# LiDAR Quality Assessment Report

AR\_Upper-White-Village\_2012

FEMA VI - Upper White Village Lidar

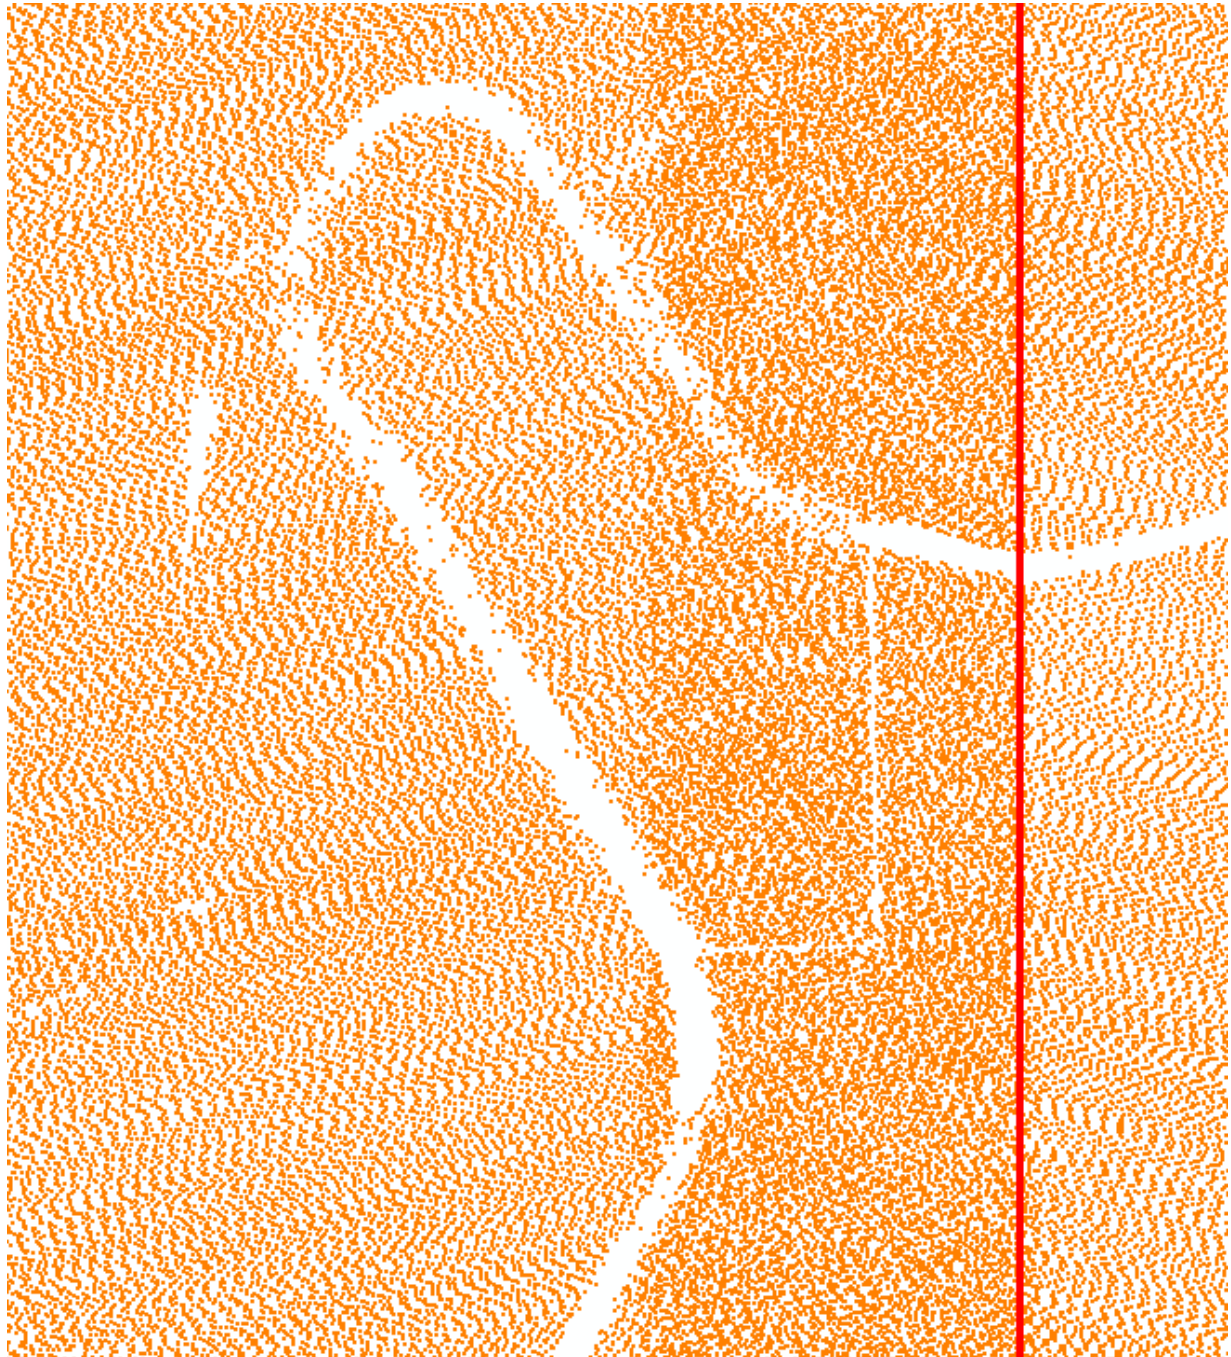
This double line drain was not hydro-flattened. It appears to have a 100' nominal width. Please correct.

04/25/2013: Double line drain is hydro-flattened, and breakline was delivered. Breaklines and hydro-flattening are accepted.

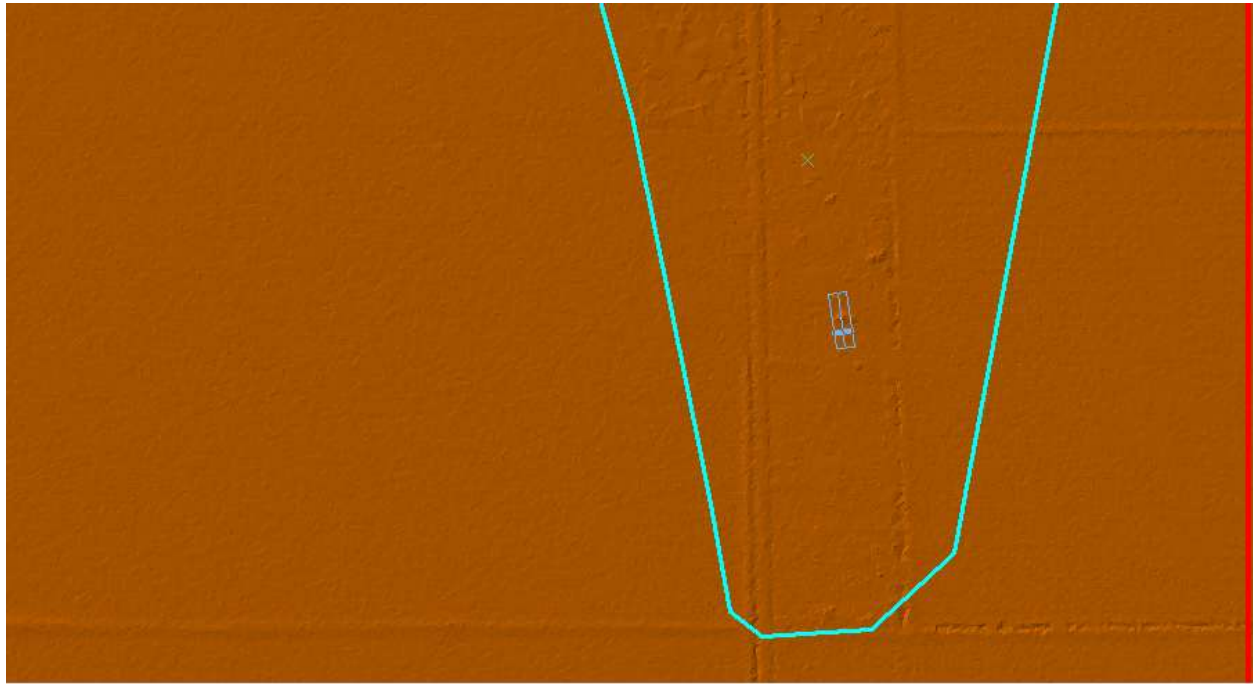
This is one example of an error that was seen several times in this project. Some points that look to be vegetation are classified as ground. Please fix.

04/25/3013: Points were fixed, vegetation was removed from the DEM. All vegetation errors have been corrected.

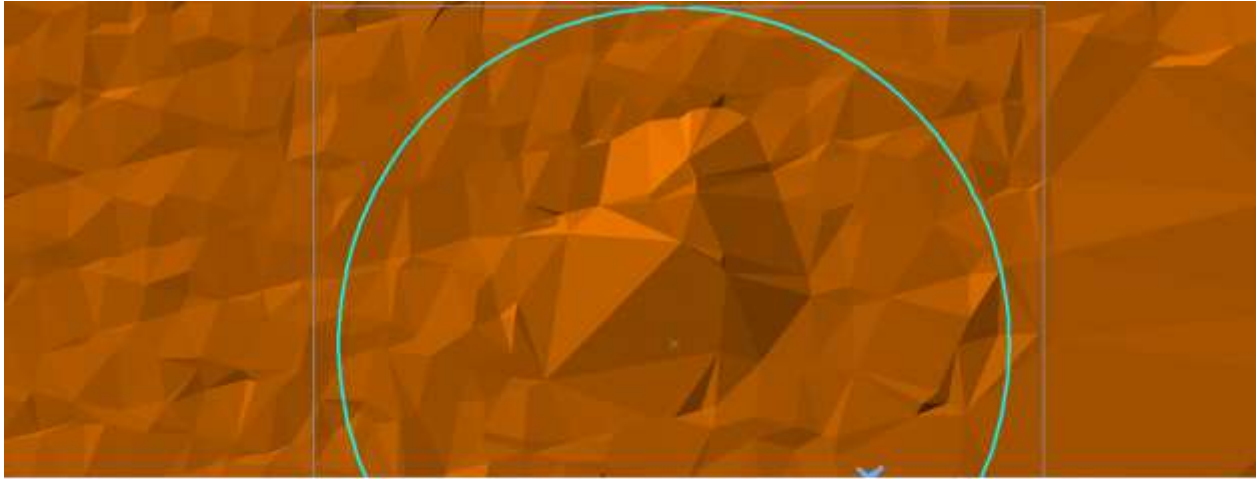
This is an example of some sort of artifact that remained in the DEM. It appears that some of the points classified as ground are misclassified and need to be corrected.

04/25/2013: Point classifications have been corrected, and as a result, the artifacts found in the initial QA are no longer in the DEM data. All artifact errors noted have been corrected.
